SERVICE BULLETIN Amateur Radio Division

SUBJECT TS-940S MRF-485 Driver Transistor Notes

DATE January 16, 1992

Size Document Number SB-980

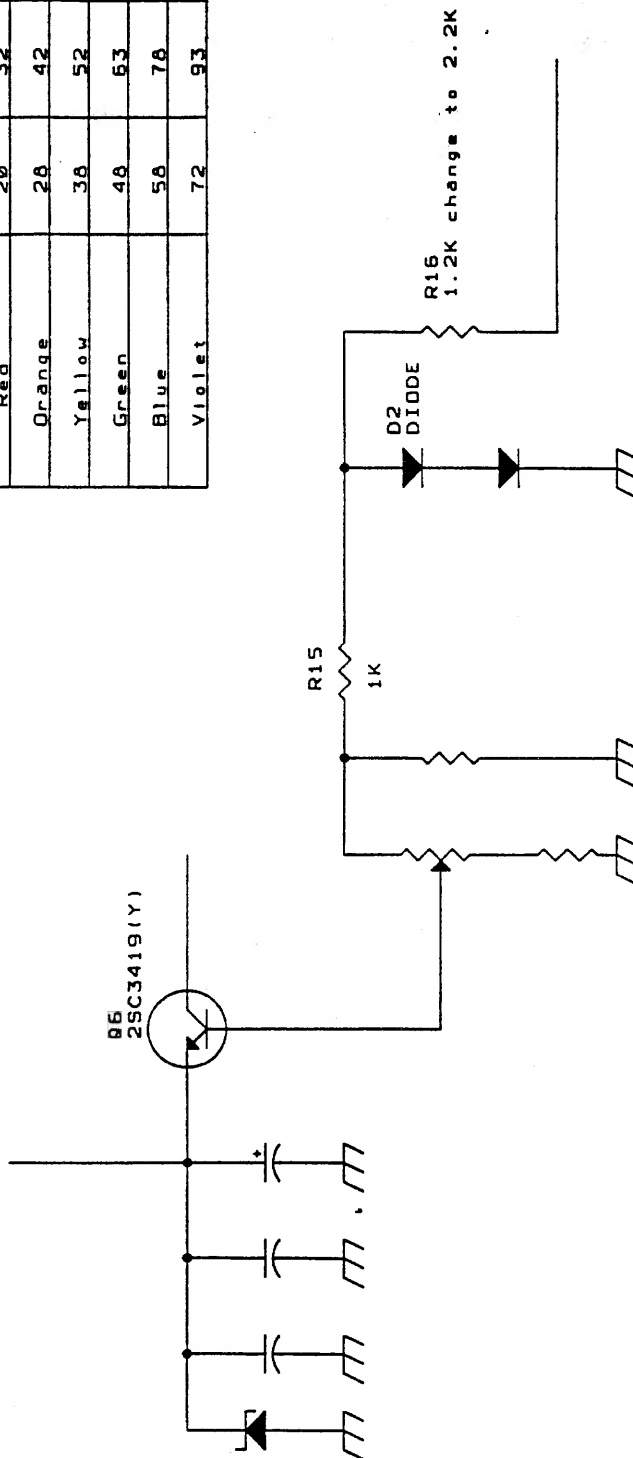
Some MRF-485 transistors are being supplied by Motorola with a Green or Blue color ranking. If these transistors are installed without modifying the driver bias circuit there is a very strong possibility that they will fail within a very short time frame.

These high gain transistors cause the circuit to become unstable which can cause the circuit to break into self oscillation, and therefore self-destruct.

During its production the TS-940S used two different varistor values. The original part was an STV3H (O). It was changed in mid-production to an SV-03YS. R15 was changed from an 820 ohm resistor to a 1K ohm resistor at the same time. Therefore the countermeasure differs depending upon the serial number of the radio.

Use of Red, Orange, or Yellow hfe color rankings is recommend. These lower gain transistors work just fine and do not suffer from the circuit instability problem. If you are only able to obtain the higher gain transistors you will need to modify the varistor/temperature compensation circuit on the final unit (X45-1400-00) by changing R16 from 1.2K to 2.2K ohms.

Caution: If using a Green or higher hfe rank one of the above countermeasures must be taken depending upon the serial number of the set. After replacing the drivers check the bias current. We recommend transmitting for 1 hour in the SSB mode with no modulation into a dummy load. After this time frame check the bias current. It must not exceed 300 mA on the original radio. If the current changes you must change R16 from 1.2K to 2.2K.
